Access Compliance Report

Public Rights-of-Way

(Curb Ramps)

Intersection ID: 10012530	Main Street: CARLEEN_WAY_DR	Cross Street: N/A	Location: W
ADA ID: 2383C8947D0B	Ramp Type: PerpDiag	Initial Pass/Fail: Fail	Overall Compliance: No
Codes/Mitigation Info/Possible Solution		Field Measurements/Component Compliance	
Severity Score: 36.25

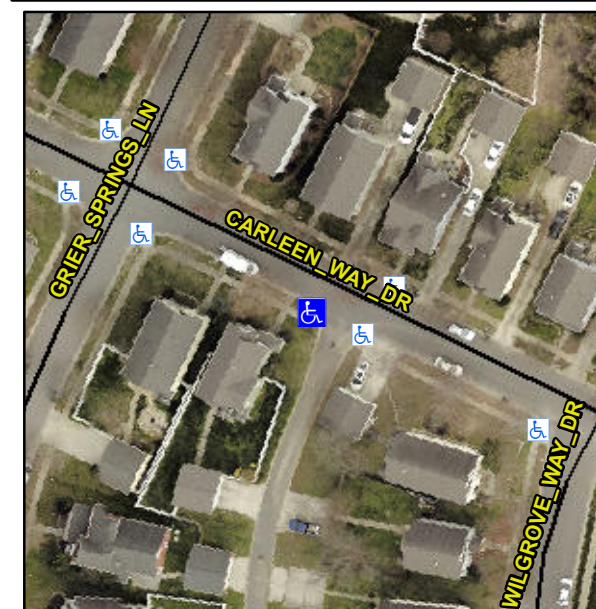
Not Found, R304.5.1, R304.5.3

Compliance	Description	Data	Compliance	Description	Data
N/A	Ramp Length (in)	49.5	Yes	Ramp Slope (%)	7.2
No	Ramp Width (in)	29.0	No	Ramp XSlope (%)	3.4
N/A	Flare Type LT	N/A	N/A	Flare Type RT	N/A
N/A	Flare Slope LT (%)	N/A	N/A	Flare Slope RT (%)	N/A
N/A	Flare Traversable LT?	N/A	N/A	Flare Traversable RT?	N/A
N/A	Landing Length (in)	N/A	N/A	DWS Provided?	N/A
N/A	Landing Width (in)	N/A	N/A	DWS Contrast?	N/A
N/A	Landing Slope (%)	N/A	N/A	DWS Length (in)	N/A
N/A	Landing X Slope (%)	N/A	N/A	DWS Full Width?	N/A
N/A	Landing Curb? (Y/N)	N/A	N/A	DWS Offset (in)	N/A
N/A	Shared Landing?	N/A			
N/A	Gutter Ponding?	N/A	N/A	Gutter Slope (%)	N/A
N/A	Gutter Lip Ht (in)	N/A	N/A	Gutter X Slope (%)	N/A
N/A	Painted X Walk1?	No	N/A	Painted X Walk2?	No
	X Walk 1 Direction	To SE		X Walk 2 Direction	To NE
N/A	X Walk 1 Width (in)	N/A	N/A	X Walk 2 Width (in)	N/A
	X Walk 1 Slope (%)	2.8		X Walk 2 Slope (%)	0.9
	X Walk 1 X Slope (%)	0.5		X Walk 2 X Slope (%)	2.6

Remove & Replace Curb Ramp With Two New Directional Ramps or Equivalent.
